Notice of Intent

Type of Action Plug and Abandonment

Plug and Abandonment Procedure
for
DJR Operating, LLC
Pete Morrow 2
API # 30-045-27685
SW/NE, Unit G, Sec. 1, T25N, R12W
San Juan County, NM

BLM FLUID MINERALS Geologic Report

DJR Operating, LLC
Proposed Wellbore Diagram

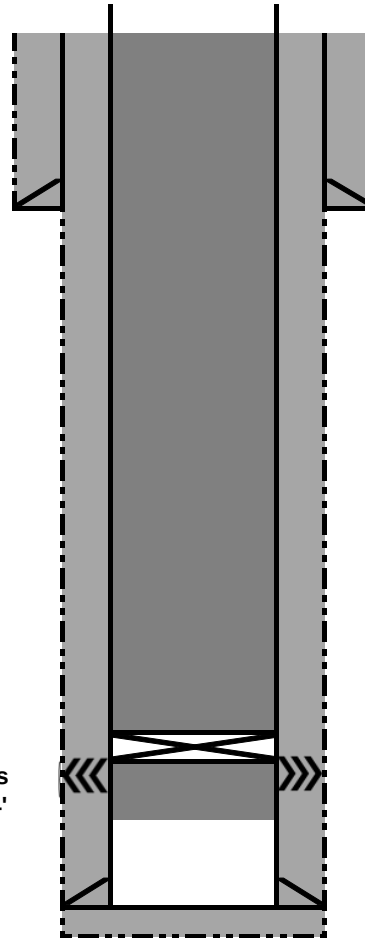
- The proposed plugging plan, if executed as presented, will adequately protect the freshwater sands in this well bore.

- Please ensure that the tops of the Pictured Cliffs and Fruitland formations as well as the entire Ojo Alamo aquifer, identified in this report, are isolated by proper placement of cement plugs. This will protect the freshwater sands in this well bore.
